# Assessment Officer Report

PA2302328

Lot 29 Hot Plate Drive, Hotham  
Heights

Officer Assessment Report  
Development Approvals & Design

Figure 3 – Snow shed plan (Source: Application)

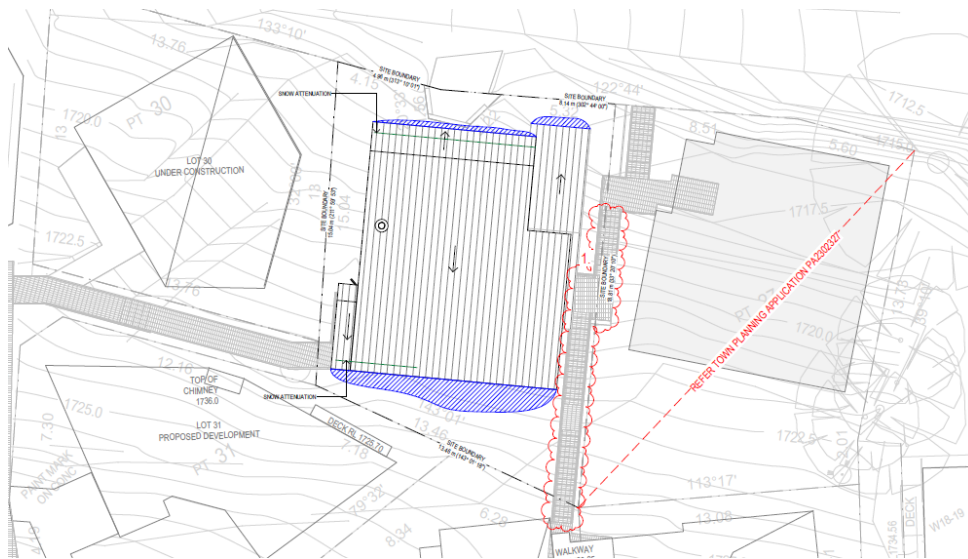
35. In terms of snow shedding, the plans show that the roof of each chalet will have a 9 degree pitch and provided with a snow retention beam. The snowshed mainly falls towards the rear of the dwelling, away from areas frequented by occupiers and guests. Furthermore, the snow dump areas will be contained within the sub-lease boundaries of the site. Snow shed areas will not be used by occupiers or guests as no access is provided to these areas. Furthermore, the steep terrain will prevent access to the snow dump areas by persons.
36. A note will be placed on the permit regarding the need to obtain a building permit, including all requirements for snow retention on the roof.

Figure 4 – Tree removal plan/location (Source: Application)

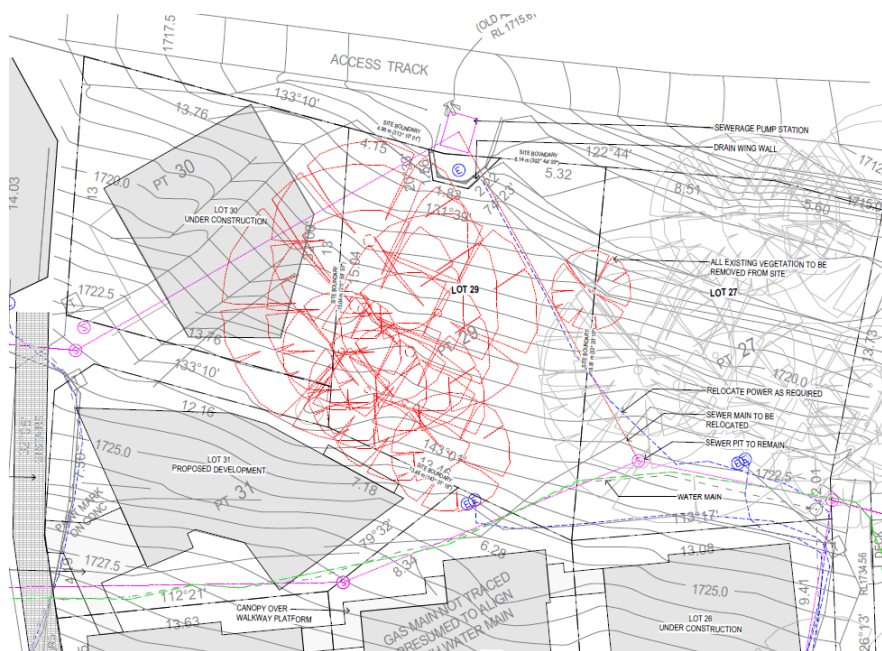
42. It is proposed to remove 0.016 hectares of native vegetation, comprising of EVC 43 patch vegetation, including seven trees. Two large trees within the patch are being removed, which fall within development footprint. 0.021 species habitat units for Woolly Billy-buttons, *Craspedia maxgrayi* s.s., including the protection of at least two large trees is required as offsets.

43. The application was referred to DEECA, who have the delegation from the Secretary to the Department of Environment, Energy, and Climate Change (as constituted under Part 2 of the Conservation, Forests and Lands Act 1987). DEECA do not object to the proposal and have included conditions to offset the removal of 0.016ha of native vegetation and for the evidence to be provided prior to the removal of any vegetation. Other conditions to be included will ensure good practices are adhered to during construction and vegetation to be retained is well protected.

**Figure 7 – Proposed vegetation removal, showing proposed clearing in red and previously approved clearing in green (Source: Application)**

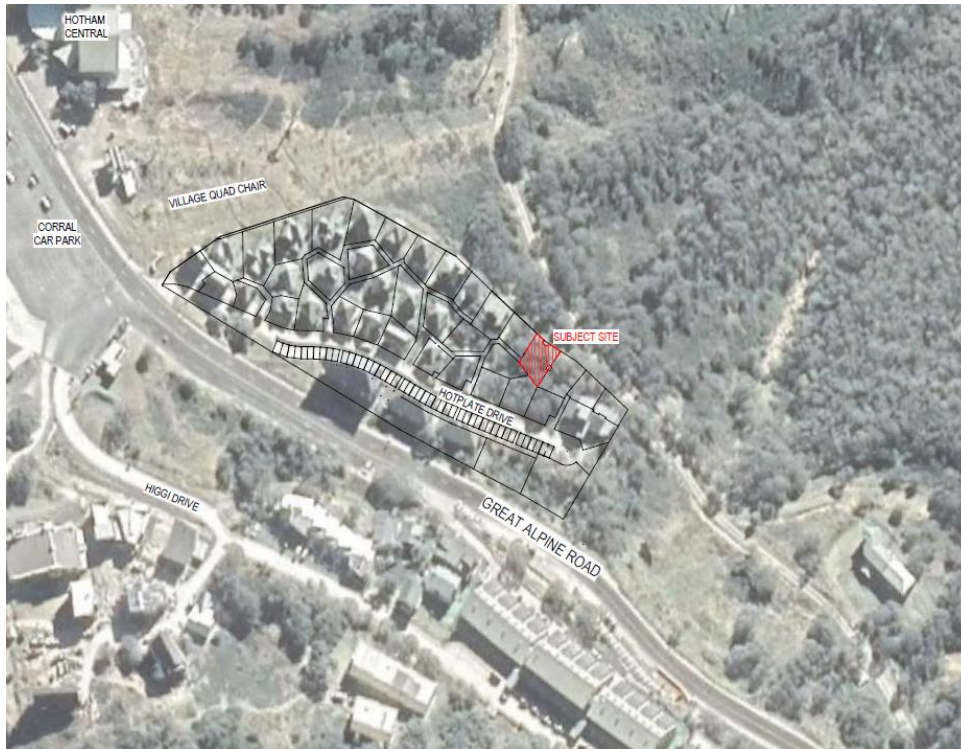
- The Flora and Fauna Assessment Report identified 7 snowgum trees proposed for removal on the site, which fall within the development footprint. Four trees on the south boundary were removed under past approved clearing (under planning permit PA2101188), which have been offset.
